**ADDENDUM NO. 1  
TO THE**

**GARDENDALE AND VILLAGE PARK WEST PRESSURE REDUCING STATION (PRS) REPLACEMENT PROJECT**

June 10, 2024

## **ADDENDUM NO. 1 DRAWING REVISIONS**

#### GENERAL NOTES

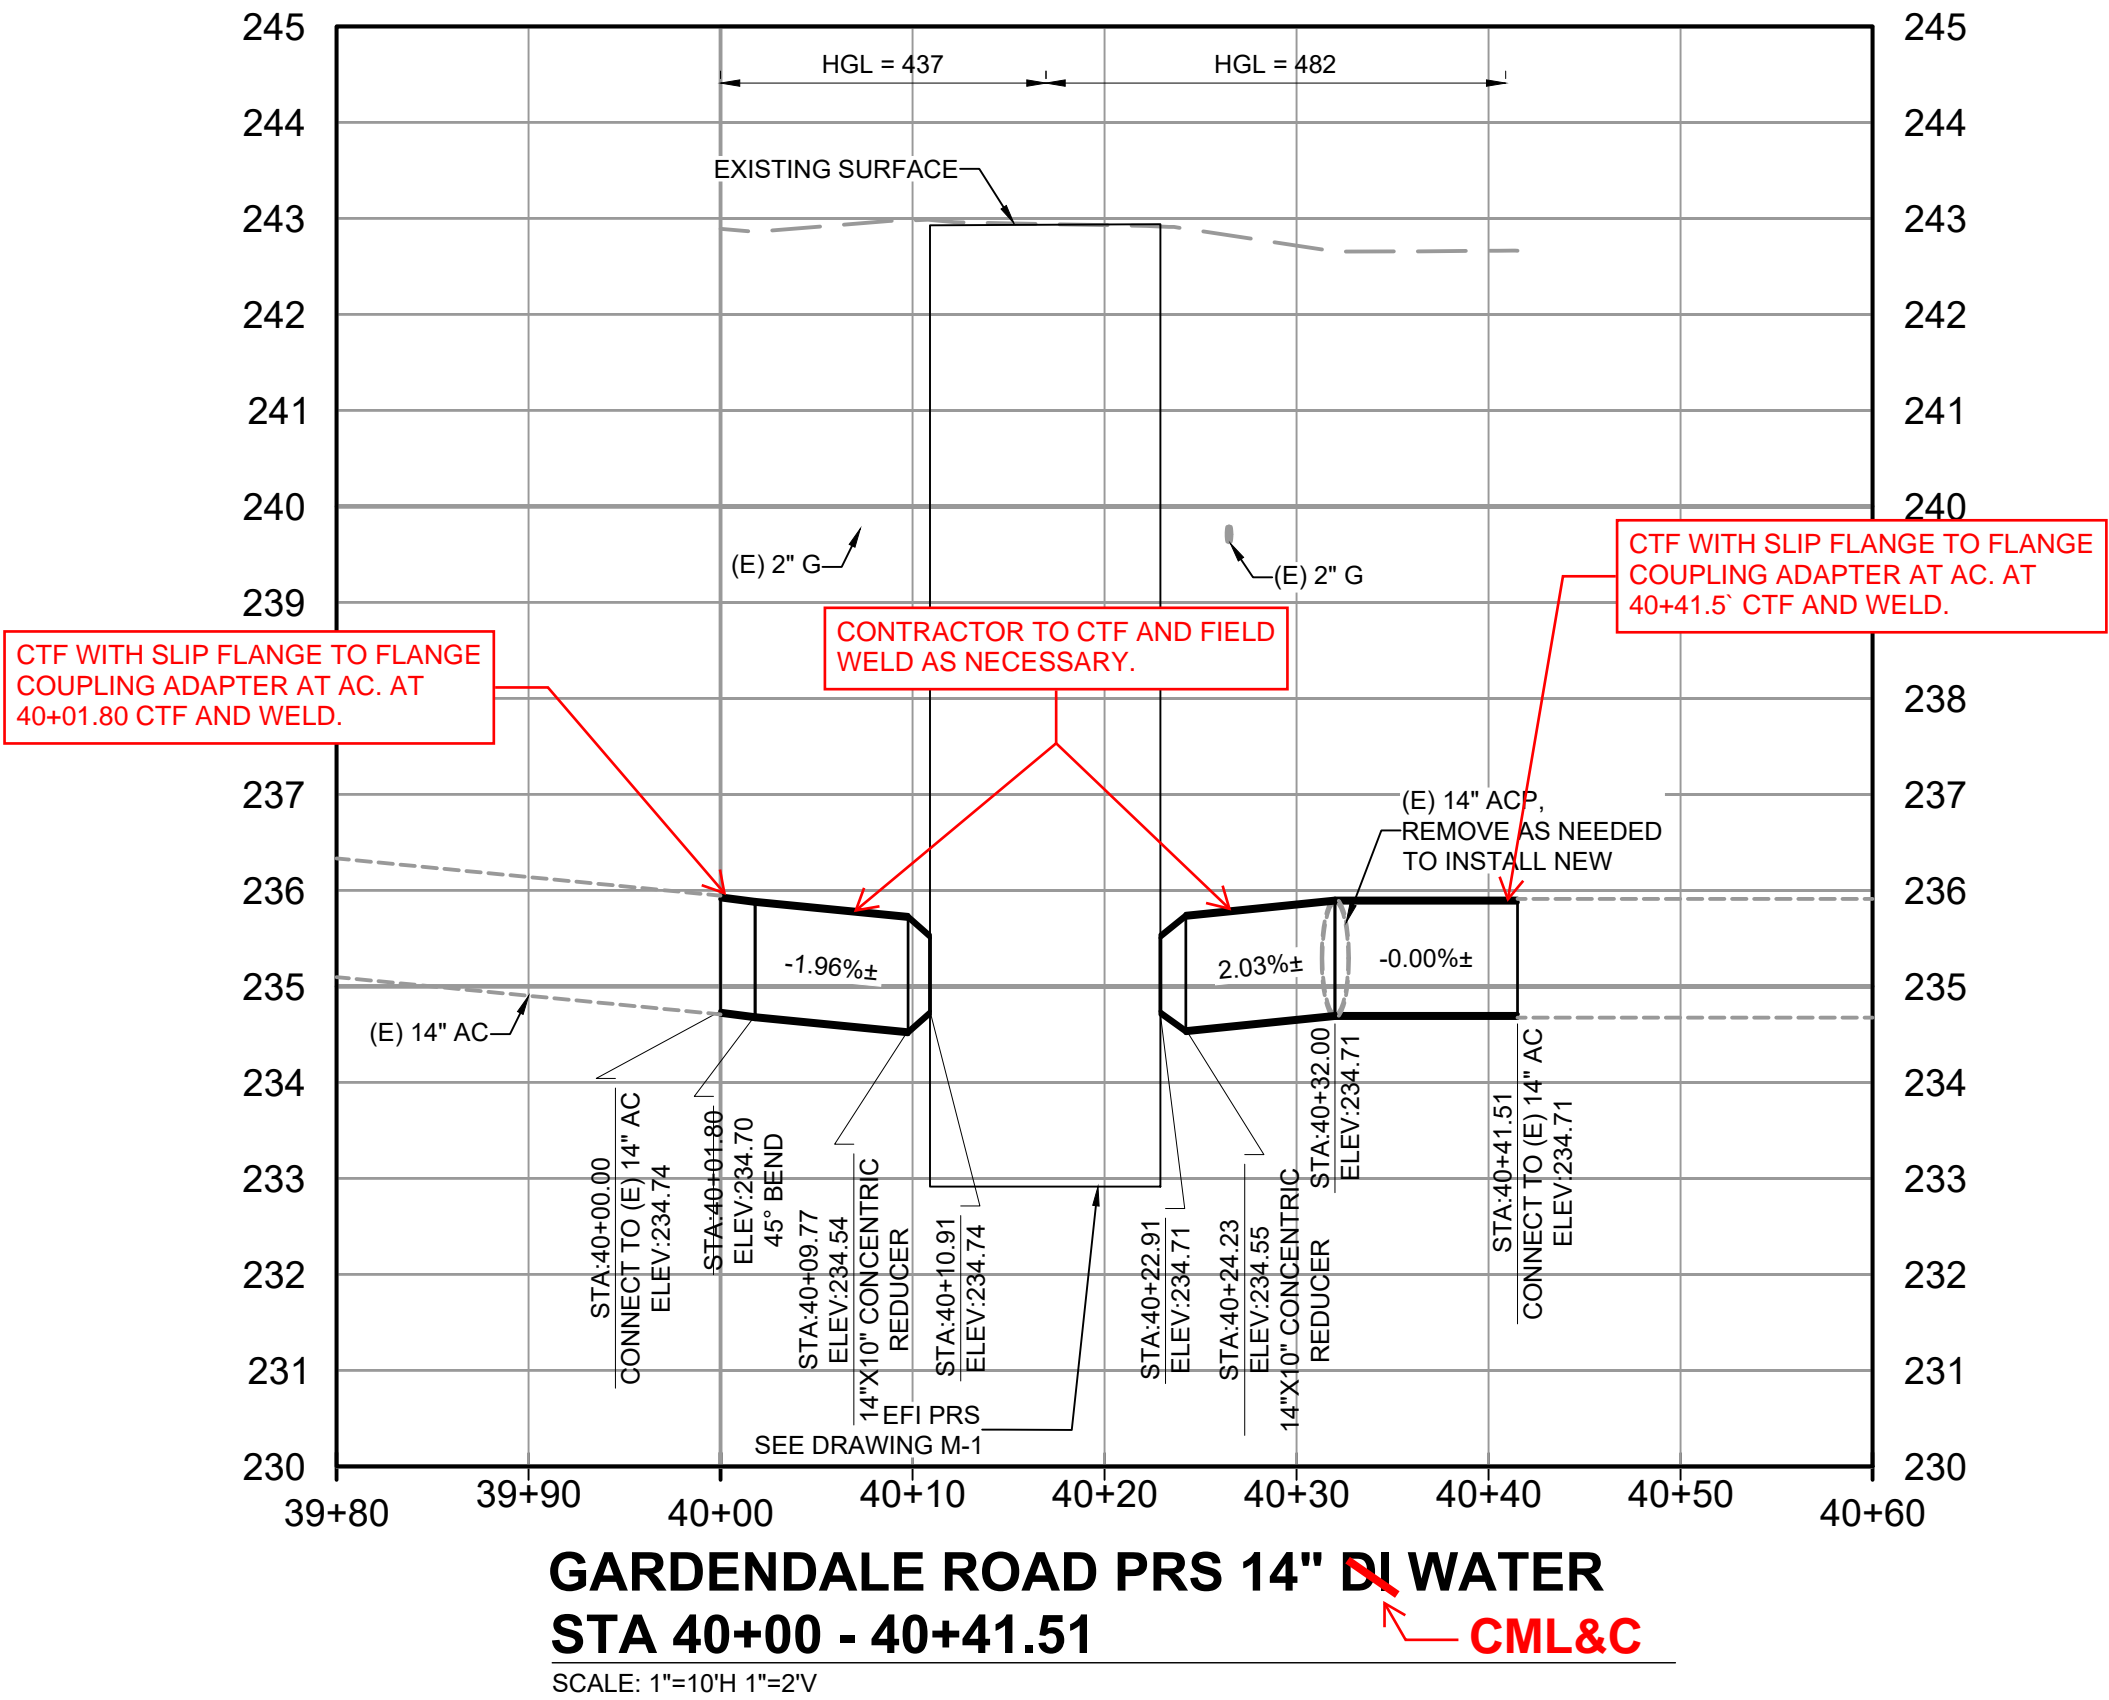
6. Q: What is the minimum offset the SDG&E relocation will be from existing pressure reducing station (PRS) that is called for demo on drawing C-2?  
**A: Contractor shall assume a minimum 5ft offset between the relocated gas line and existing PRS. Contractor shall field locate final alignment of the relocated gas line per C-2.**

1. Drawing G-2 General Notes; **REVISE** per attached Drawing
2. Drawing C-1 Village Park West PRS, Wandering Road 10" Waterline Improvements; **REVISE** per attached Drawing
3. Drawing C-2 Gardendale Road 14" Waterline Improvements; **REVISE** per attached Drawing
4. Drawing C-3 PRS Piping Profiles I; **REVISE** per attached Drawing
5. Drawing C-4 Curb Outlet Sections; **REVISE** per attached Drawing
6. Drawing C-5 PRS Piping Detail I; **REVISE** per attached Drawing
7. Drawing C-6 PRS Piping Detail II; **REVISE** per attached Drawing
